# SERVICE BULLETIN

ENGINE - LP TURBINE - REMOVE THE CORRELATION MARKING ON THE STAGE 6 INNER AIRSEAL -  
CATEGORY CODE 6 - MOD.ENG-72-0089

V2500-ENG-72-0089

Stage 6 turbine inner airseal, position of correlation marking  
Fig.1

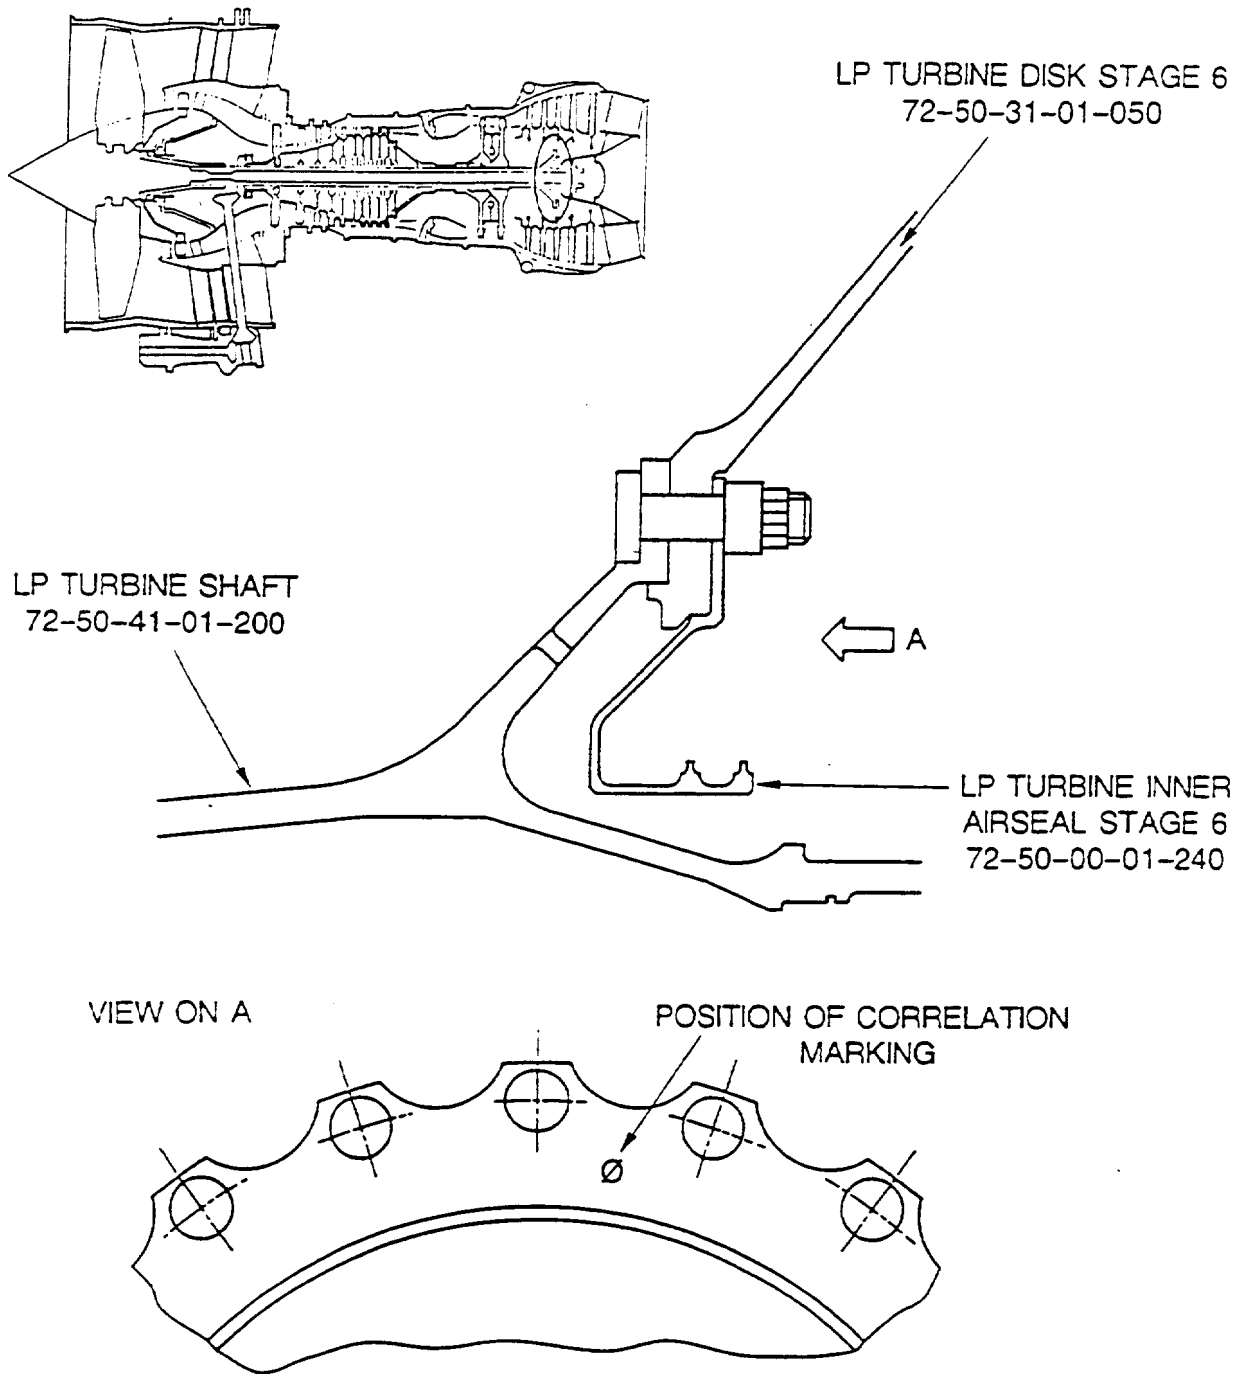
- (1) Identify the correlation marking on the stage 6 turbine inner airseal. Refer to Figure 1.

NOTE: The correlation marking is located on the rear side of the airseal flange.

- (2) Remove the correlation marking.

Blend repair information  
Fig.2

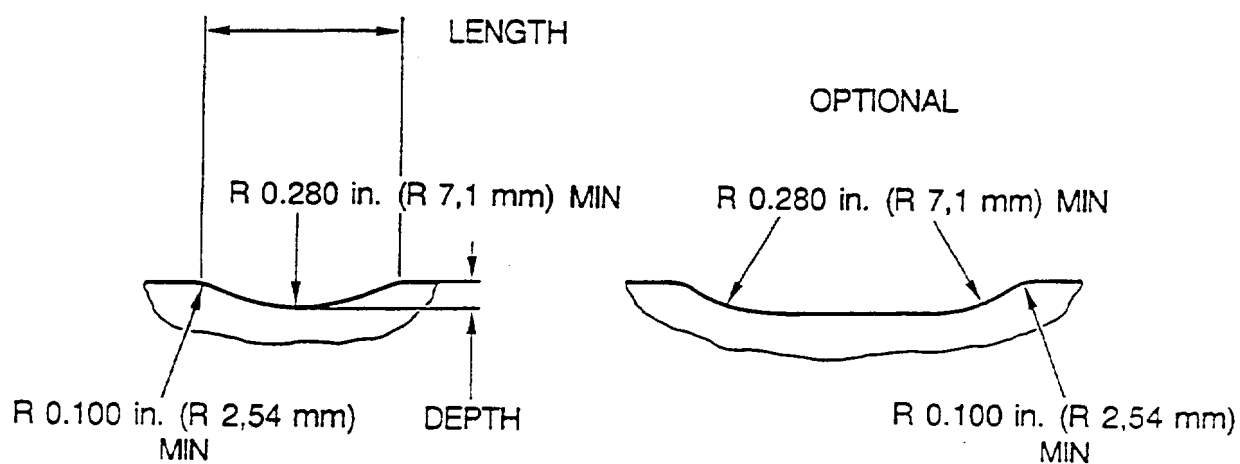
- (a) Blend repair the airseal to remove the correlation marking

Perform blend repair in circumferential direction only. keep material removal to the minimum to remove the damage. Maximum depth of blend repair is 0,010in. (0,25 mm). Length to depth blend ratio is 5:1 minimum. Refer to Fig 2.
